**AOWE ATO INSTALLATION REPORT
PACK-ONE PLLC
Stephen Bristow
920 Garner Road
Selma NC 27576
919-906-4737
Stevebristow57@gmail.com**

RE: Briarwood Subdivision Lot 38 Installation Revision- Line Revision/ Pump Tank Added
22 Knoll Way, Sanford NC 27332
PIN: 9588-65-3039

BRIARWOOD BLUFF LOT 38 "AS BUILT"

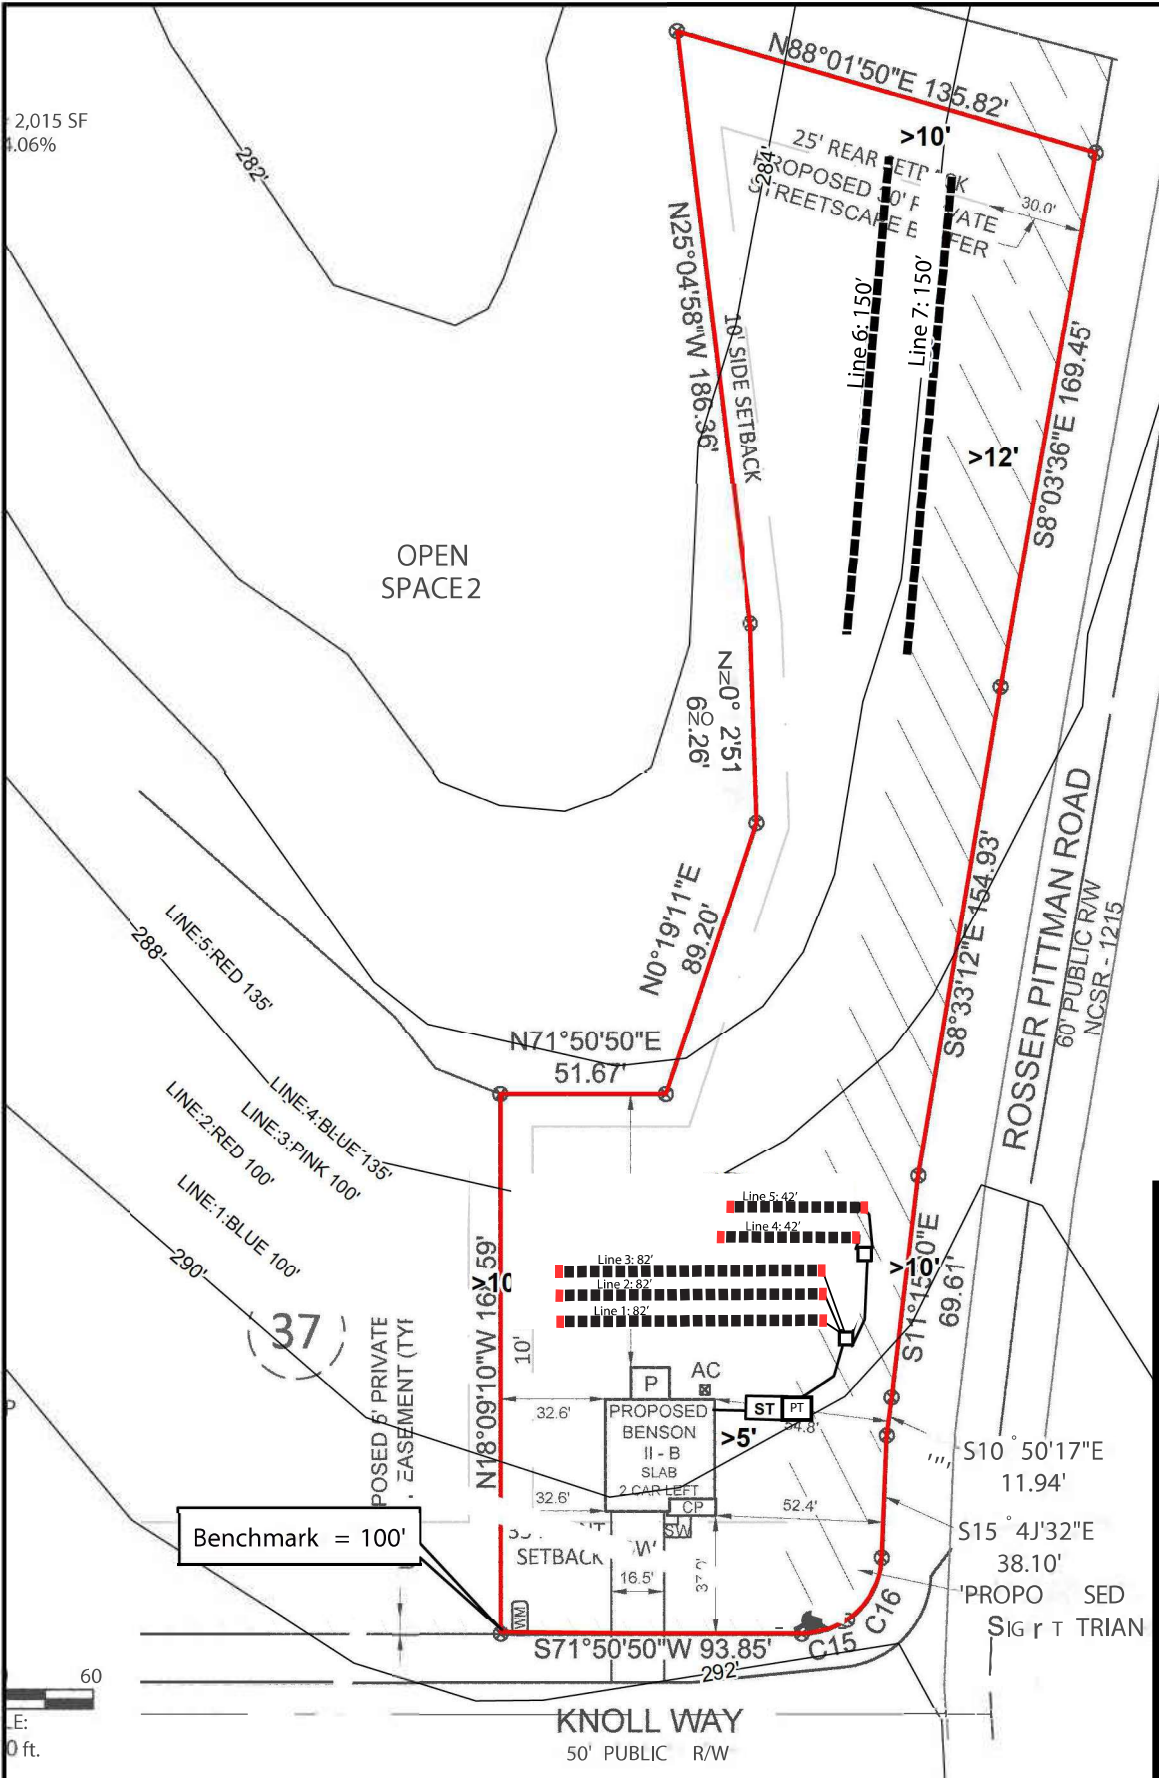
The septic drainfield was installed with a Infiltrator Quick 4 Connect System adding two endcaps to the lines. This resulted in an increased line length to 82' and 42' as seen in the attached "As Built" diagram. A pump tank was also installed and the pressure manifold detail is attached. I find these changes acceptable to meet the state requirements.
